Landscape Review Committee
Community Development Center, 231 NE 5th Street
March 20, 2019
12:00 PM

**DECISION, CONDITIONS OF APPROVAL, AND FINDINGS OF FACT OF THE MCMINNVILLE
LANDSCAPE REVIEW COMMITTEE FOR APPROVAL OF STREET TREE PLAN AND LANDSCAPE
PLAN FOR WHISPERING MEADOWS SUBDIVISION**

DOCKET: L 29-18 (Landscape Plan Review)

DATE: March 20, 2019
TO: McMinnville Landscape Review Committee
FROM: Jamie Fleckenstein, PLA, Associate Planner
SUBJECT: Agenda Item 4B: L 6-19

NE WHISPERING RIVER COURT STREET TREE PLAN / TRACT “A” LANDSCAPE PLAN (REVISED)

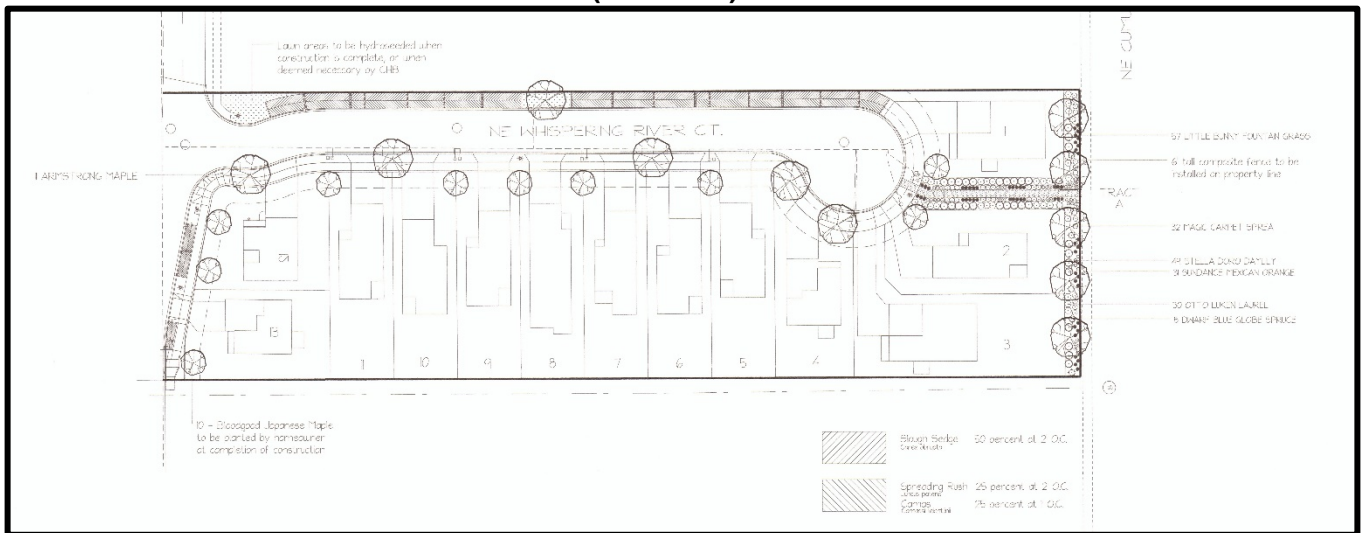
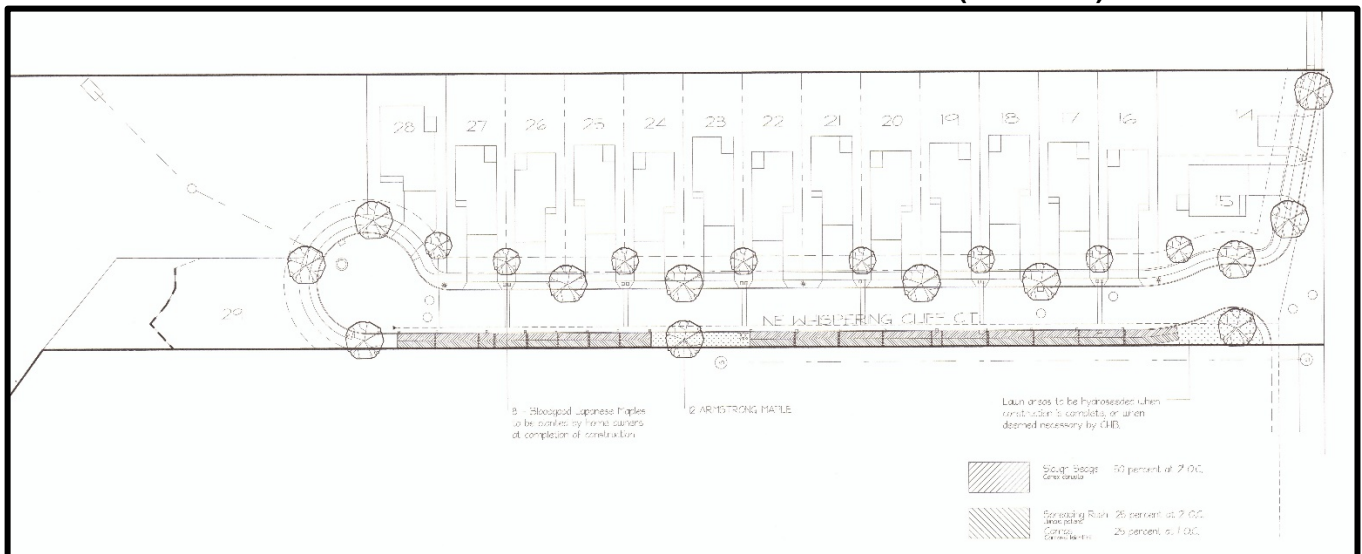
The landscape plan shows that trees are proposed straddling the property lines on lots 5 through 12 and 16 through 27. This creates situations where responsibility of ownership/maintenance is not clear. Additionally, there are gaps in the line of Bloodgood Japanese Maples, where spaces were left to accommodate street trees in the right-of-way. Staff recommends filling in the gaps by planting a tree in

each front yard of lots 5 through 12 and 16 through 27, such that there are no trees straddling private property lines and there is consistent 40 foot spacing between Japanese Maple trees. Also, street trees are shown straddling the projected shared property line between lots, creating situations where responsibility of ownership/maintenance is not clear. Staff recommends not centering the street trees in the planter strip so it is clear which lot is the adjacent property to the street tree. A street tree is proposed between lots 10 and 11 in the space between driveway accesses. Because it does not appear that there is enough space to maintain five (5) feet spacing each private driveway, staff recommends removal of the *Acer rubrum* 'Armstrong' (Armstrong Red Maple) street tree from the right-of-way between lots 10 and 11.

3. That no street tree shall be planted in the planter strip between Lots 10 and 11.
4. That street trees shall not be planted straddling the projected common property line between lots. Street trees shall have a single, clear adjacent property.

5. That *Acer palmatum* 'Bloodgood' (Bloodgood Japanese Maple) trees shall be planted one (1) per lot for all Lots, except Lot 3, at approximately 40 foot spacing. Corner lots 12 and 15 shall have a minimum of one (1) *Acer palmatum* 'Bloodgood' (Bloodgood Japanese Maple) along each street frontage.

NE WHISPERING RIVER COURT STREET TREE PLAN / TRACT "A" LANDSCAPE PLAN (REVISED)

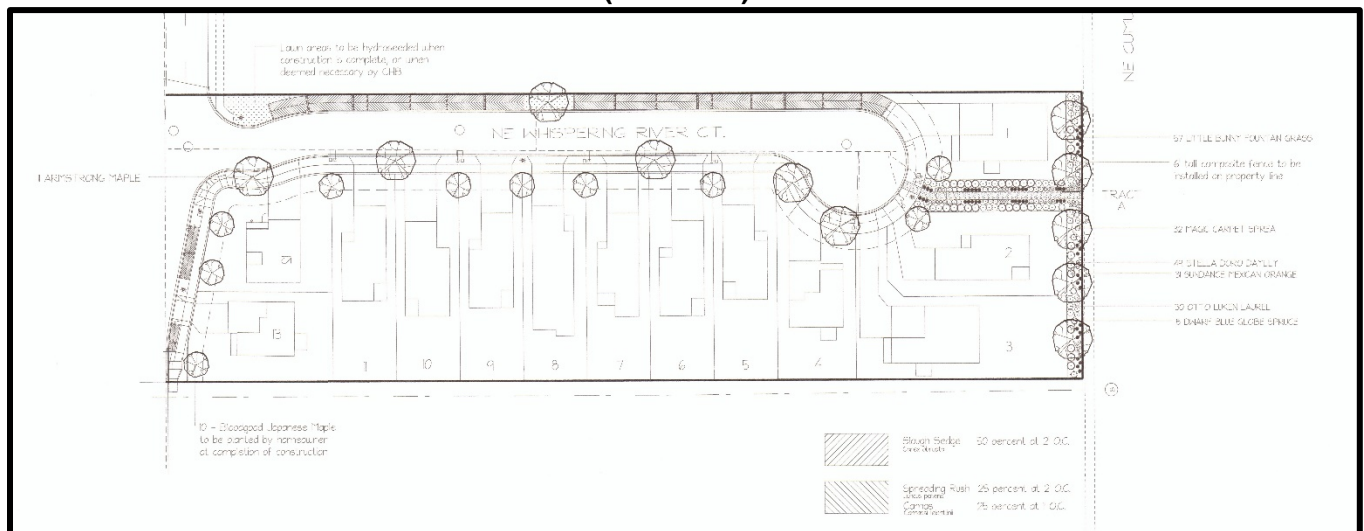
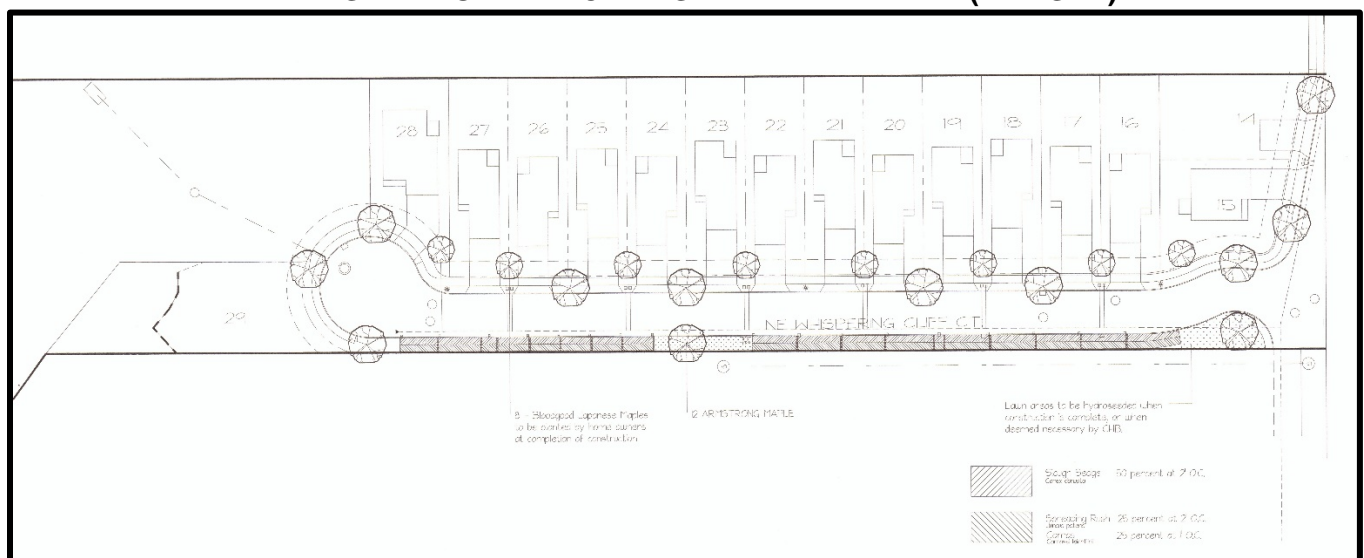
The landscape plan shows that trees are proposed straddling the property lines on lots 5 through 12 and 16 through 27. This creates situations where responsibility of ownership/maintenance is not clear. Additionally, there are gaps in the line of Bloodgood Japanese Maples, where spaces were left to accommodate street trees in the right-of-way. Staff recommends filling in the gaps by planting a tree in each front yard of lots 5 through 12 and 16 through 27, such that there are no trees straddling private property lines and there is consistent 40 foot spacing between Japanese Maple trees. Also, street trees are shown straddling the projected shared property line between lots, creating situations where responsibility of ownership/maintenance is not clear. Staff recommends not centering the street trees in the planter strip so it is clear which lot is the adjacent property to the street tree. A street tree is proposed between lots 10 and 11 in the space between driveway accesses. Because it does not appear that there is enough space to maintain five (5) feet spacing each private driveway, staff recommends removal of the *Acer rubrum* 'Armstrong' (Armstrong Red Maple) street tree from the right-of-way between lots 10 and 11.

PROJECT NO.	217-027
SHEET NO.	L 1

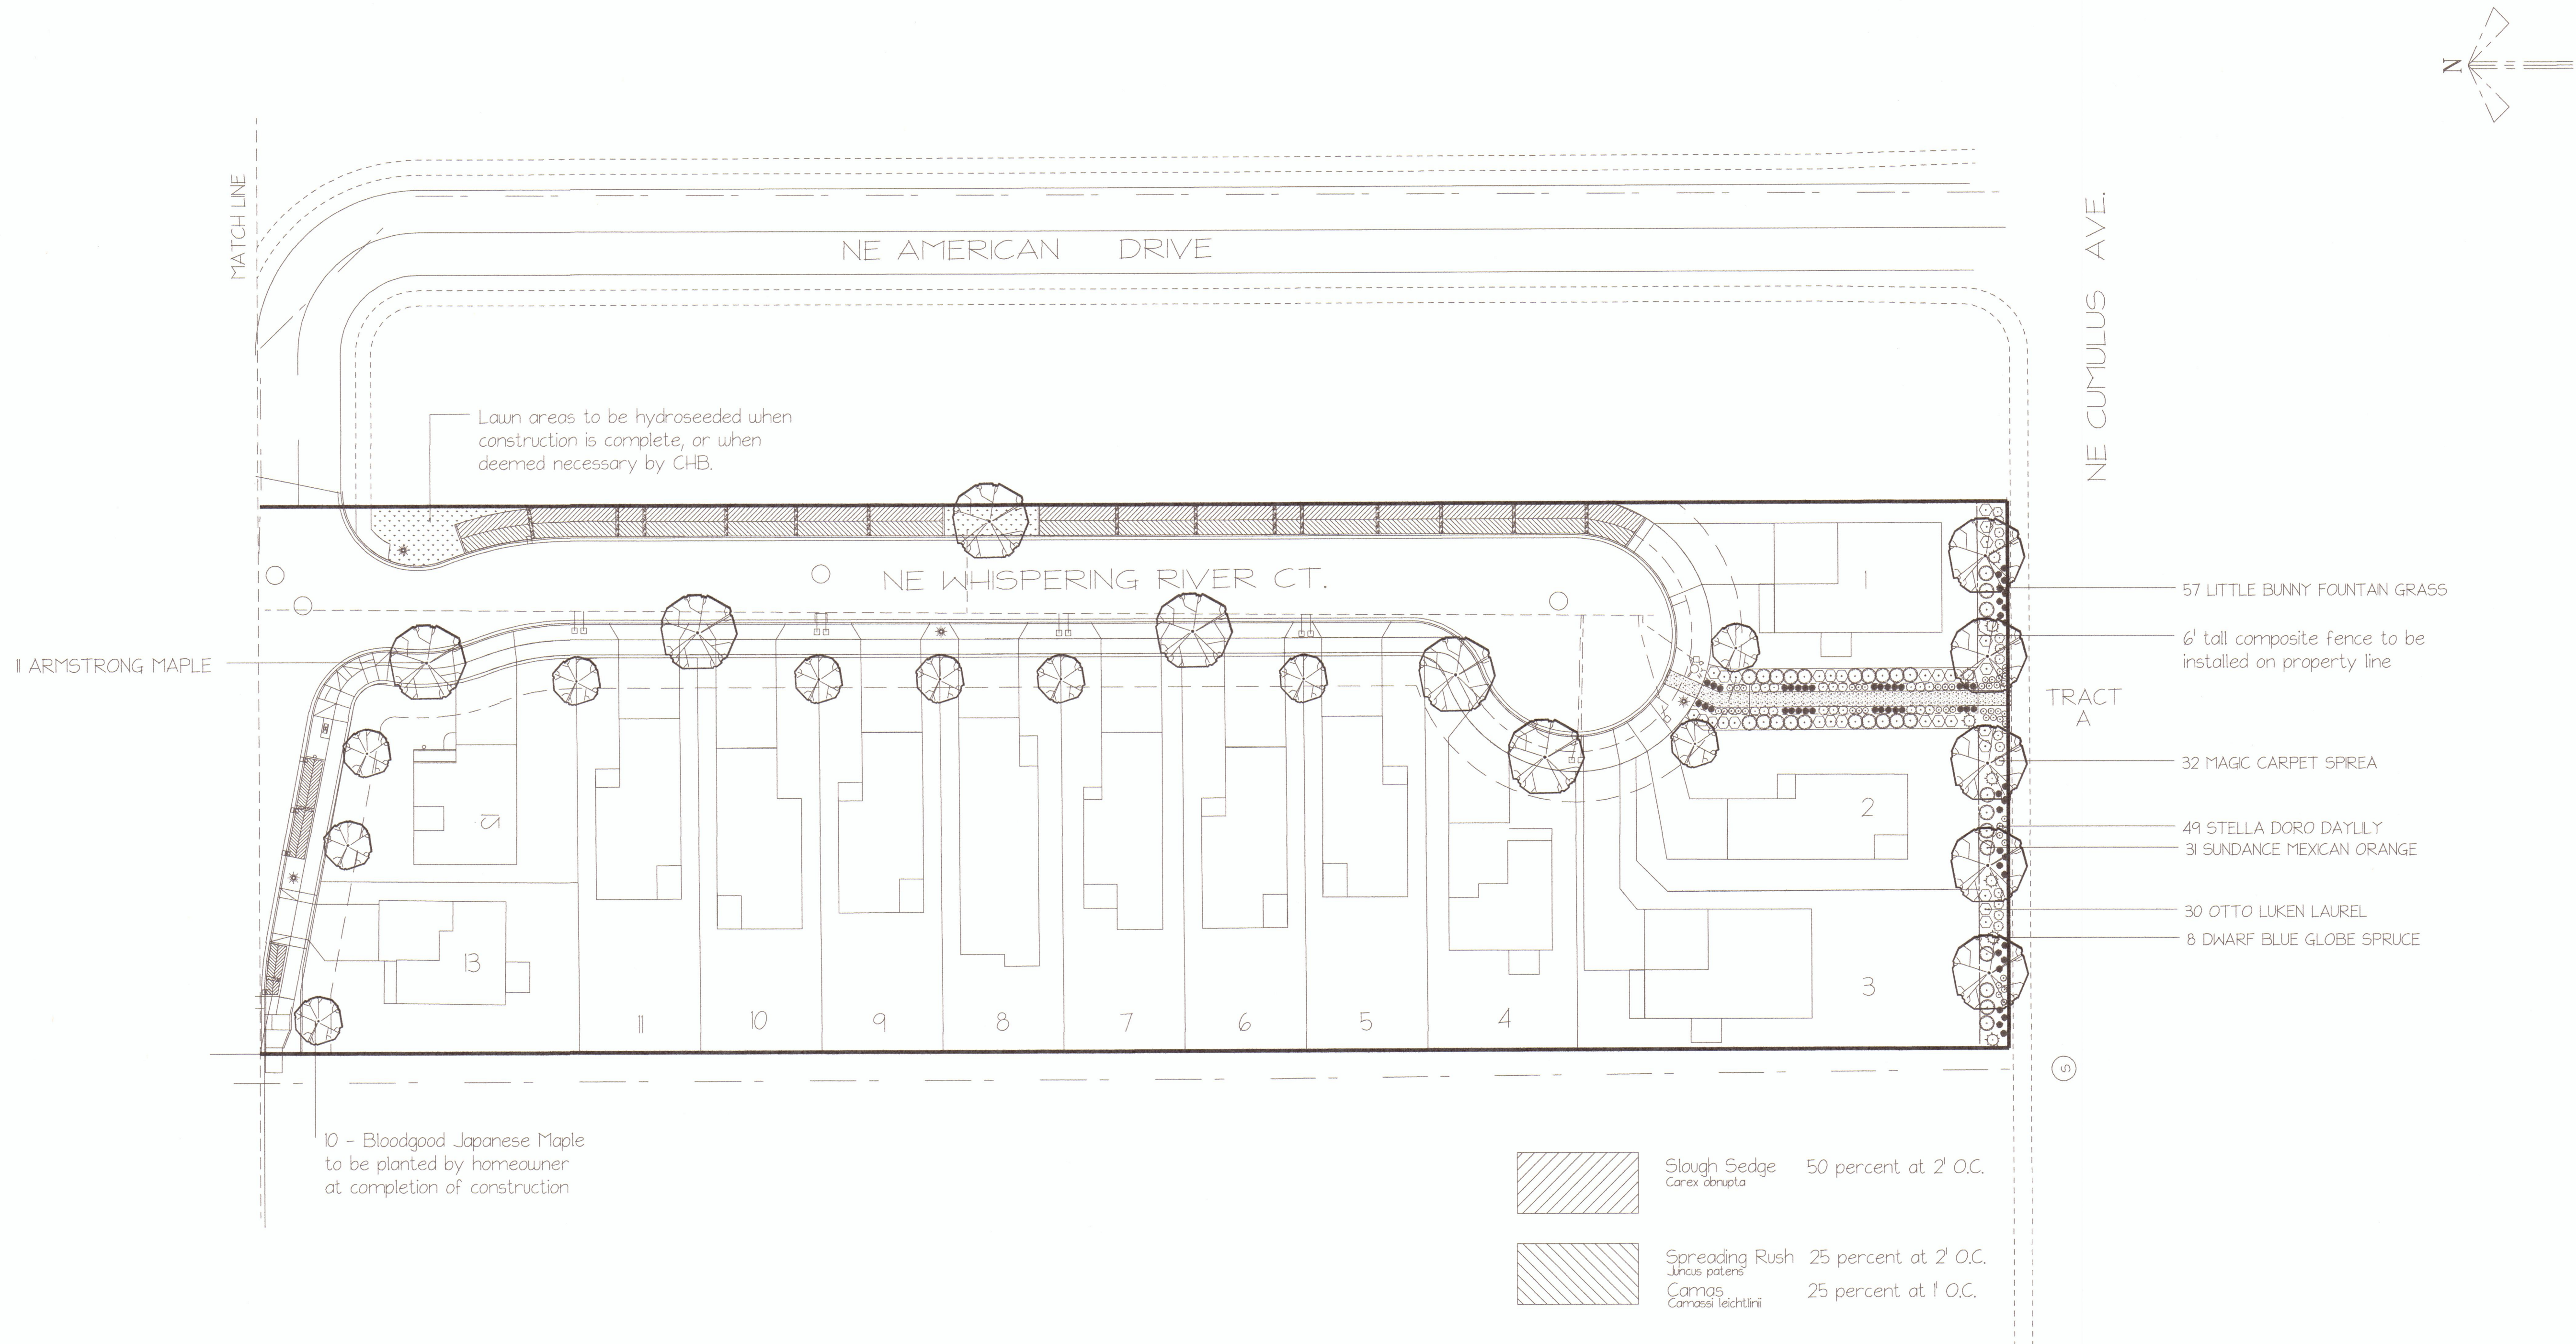
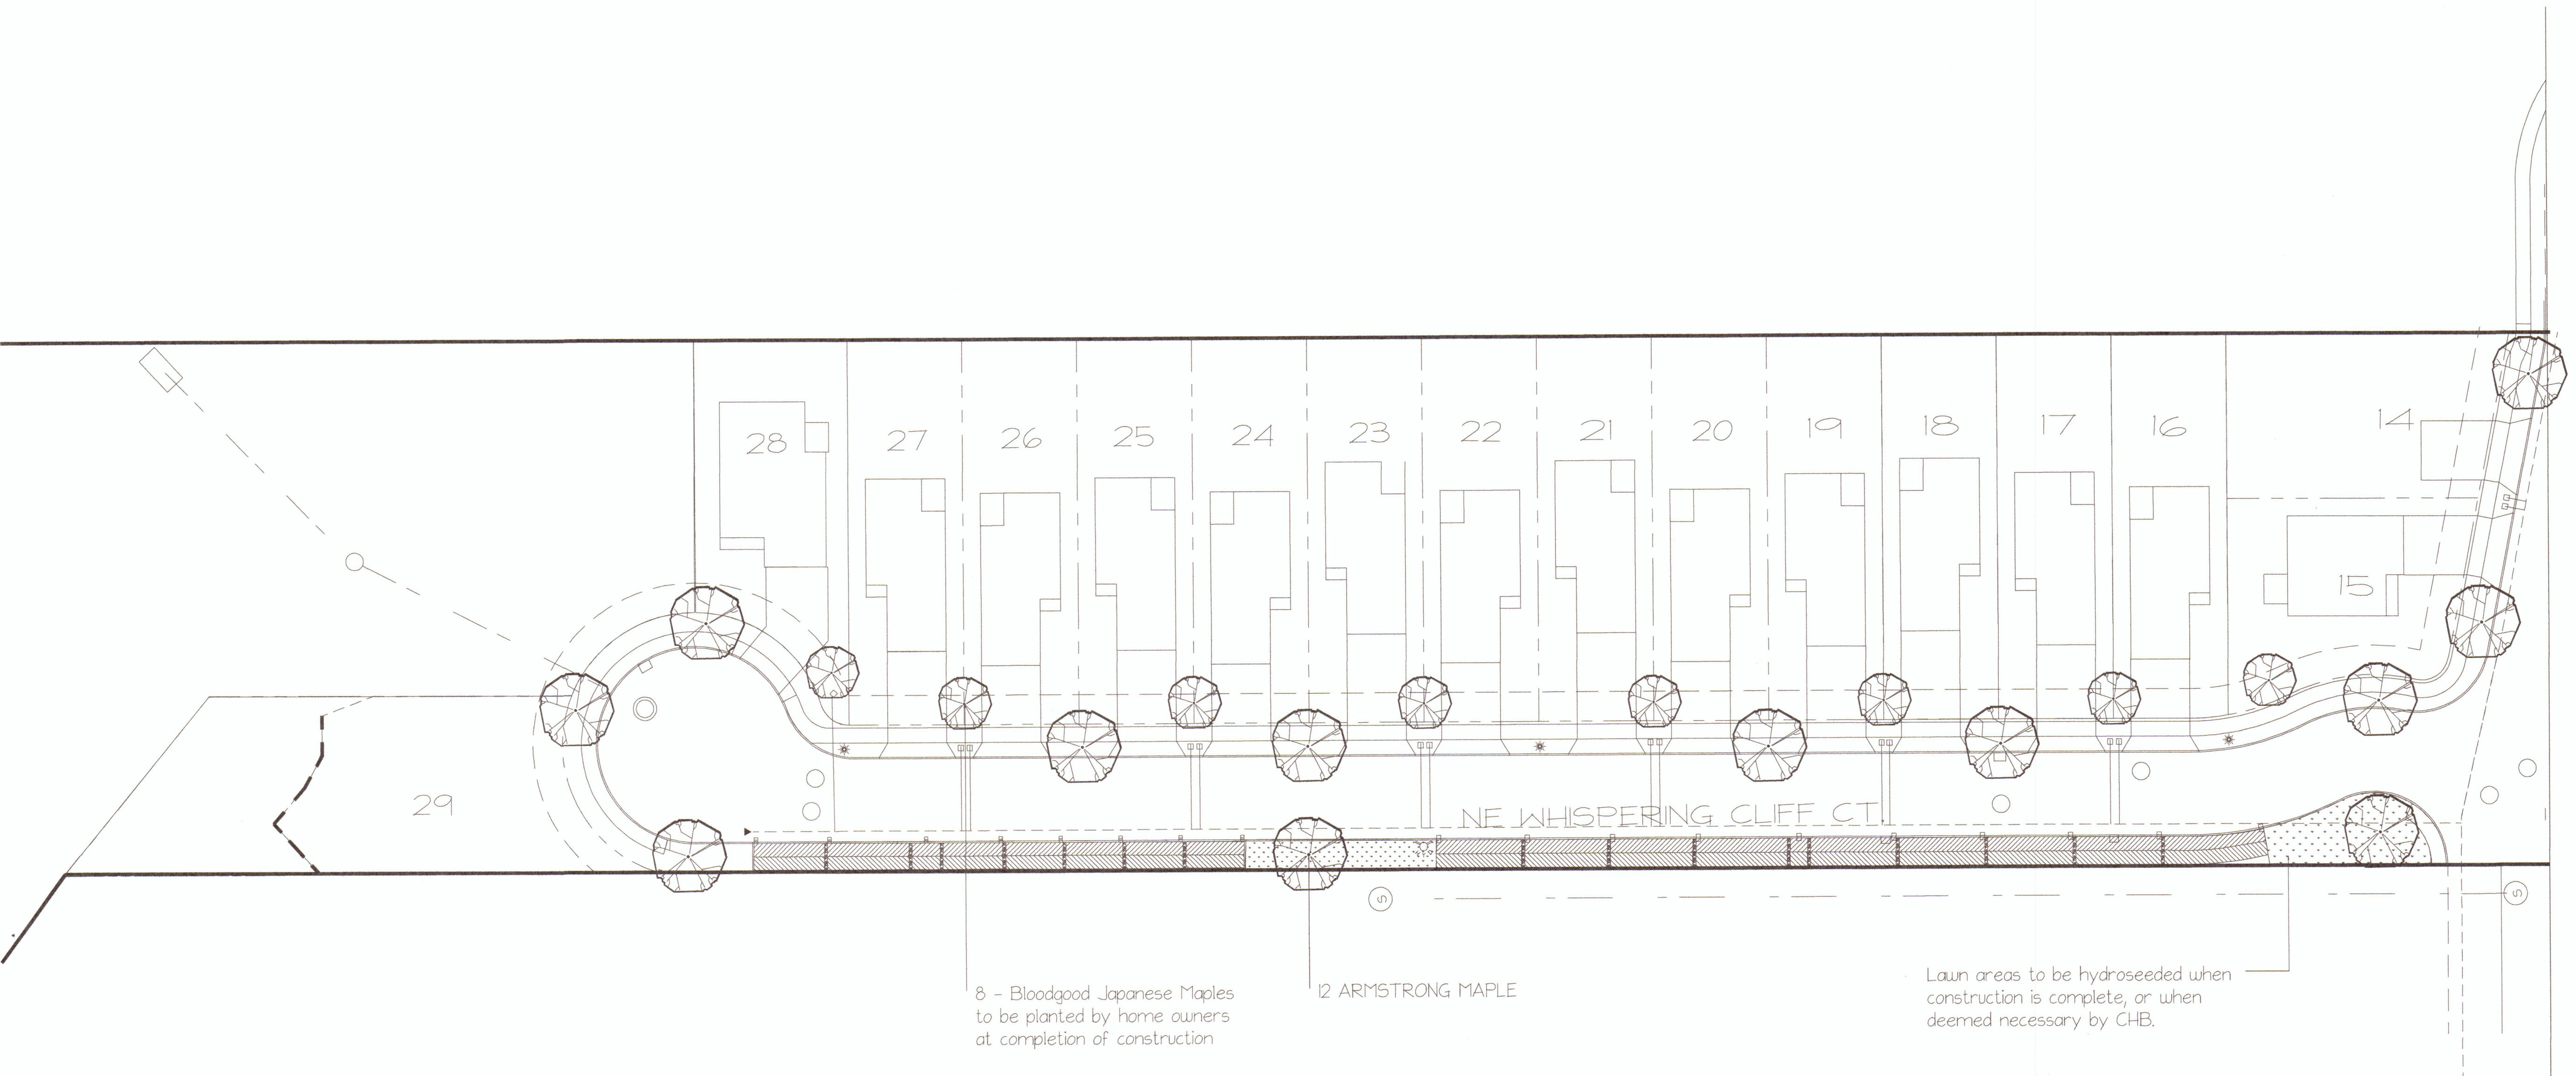
1. The Japanese maples proposed are all shown to be planted outside of the public right of way, and thus outside of our purview here at Public Works. As a note, several of these are show to be straddling the property line between two lots. So we would see two potential issues:

- a. What will be the City's ability to enforce the replacement planting of these trees in the future, unless they are somehow mandated to be kept and replaced as needed on private property?

- b. Since they straddle the property line, which lot will have planting and maintenance responsibilities, including replacement, moving forward?
2. We would note that the following areas shall be maintained by the HOA:

3. The applicant should be reminded of the spacing requirements for the planting of street trees in the ROW from driveways, light poles, intersections and utility poles.

Staff comment: A condition of approval requires that all trees meet spacing standards from water services and fire hydrants. Staff notes that minor adjustments to an approved street tree or landscape plan are allowed to meet minimum standards.
